CAA Operational Assessment

Title of airspace change proposal	TDA to enable BVLOS Demonstration of Cargo UAV within the Shetland Islands
Change sponsor	Windracers Ltd
Project reference	ACP-2024-051
Account Manager	[REDACTED]
Case study commencement date	
Case study report as at

Figure 1: Left shows ACP submission of the airspace design. Right image provides the aviation chart with overlaid flight path.

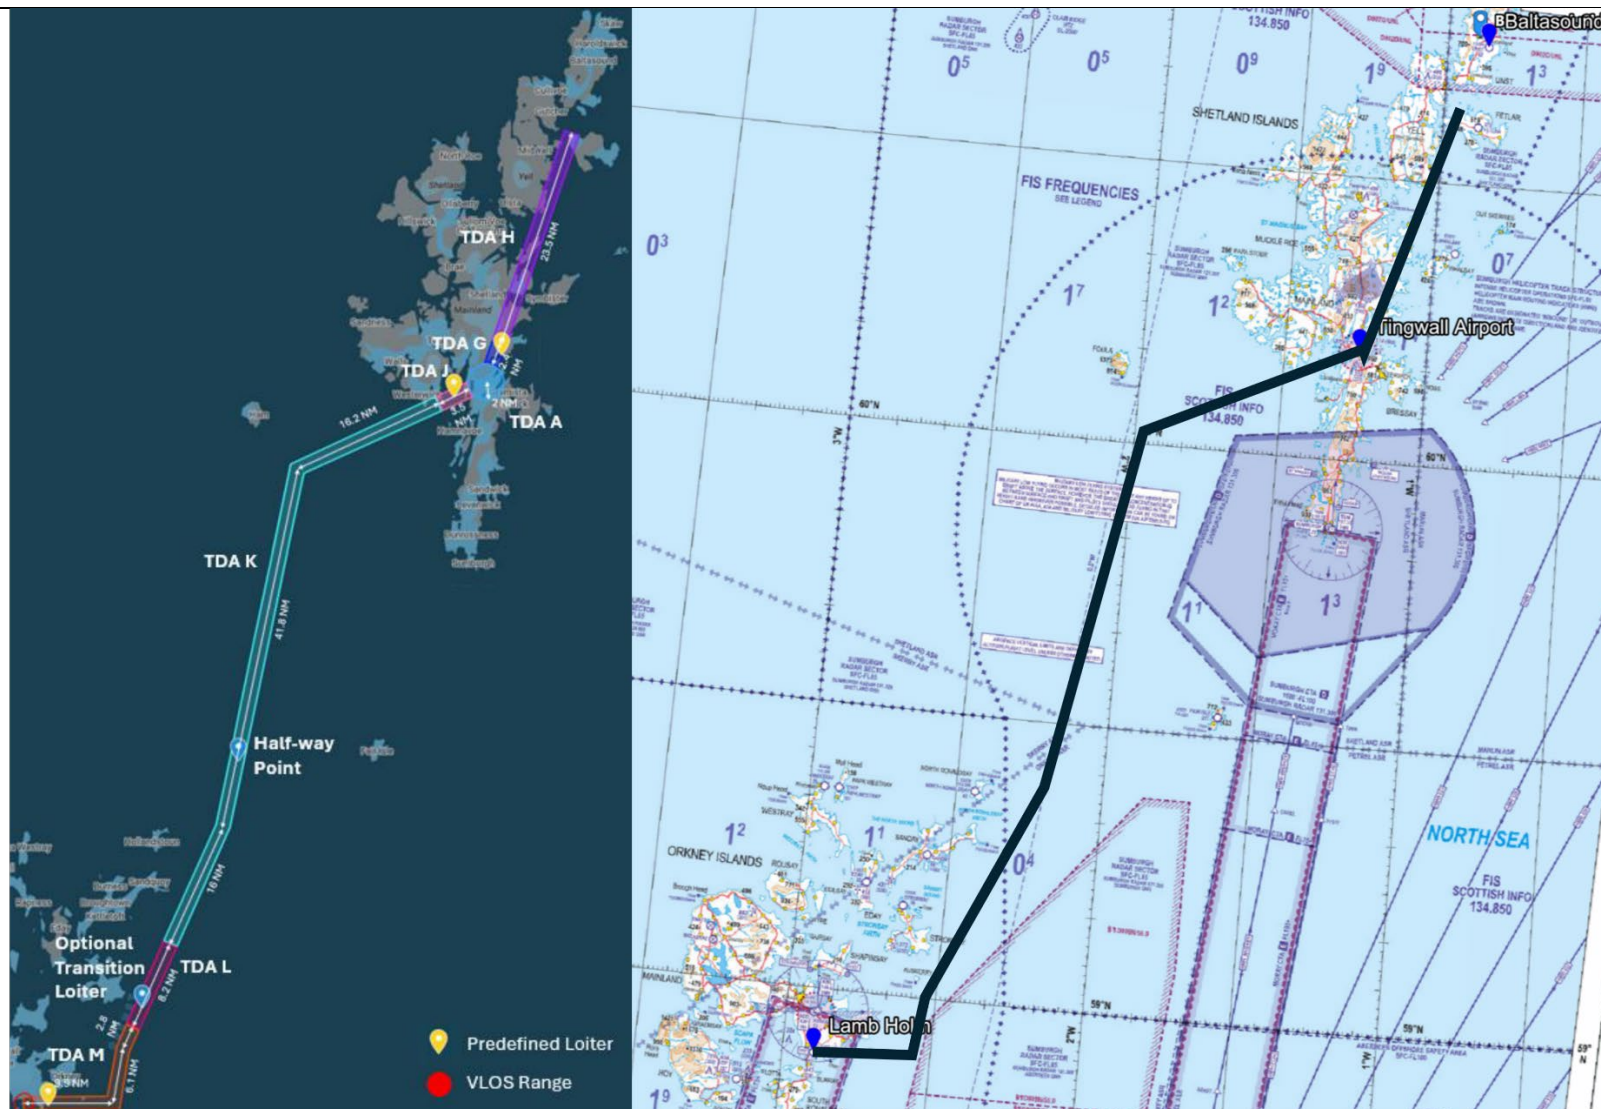
4.	Maps/charts/diagrams	Status
4.1	<p>Is a diagram of the proposed airspace included in the proposal, clearly showing the dimensions and WGS84 co-ordinates?</p> <p>(We would expect sponsors to include clear maps and diagrams of the proposed airspace structure(s) – they do not have to accord with aeronautical cartographical standards (see airspace change guidance), rather they should be clear and unambiguous and reflect precisely the narrative descriptions of the proposals.)</p>	YES
	The submission provided clear diagrams and all co-ordinates are in WGS84.

4.2	Do the charts clearly indicate the proposed airspace change?	YES
	Yes, the chart clearly indicates the proposed airspace change. I have plotted the provided co-ordinates on ArcGIS and it corresponds with the ACP submission.
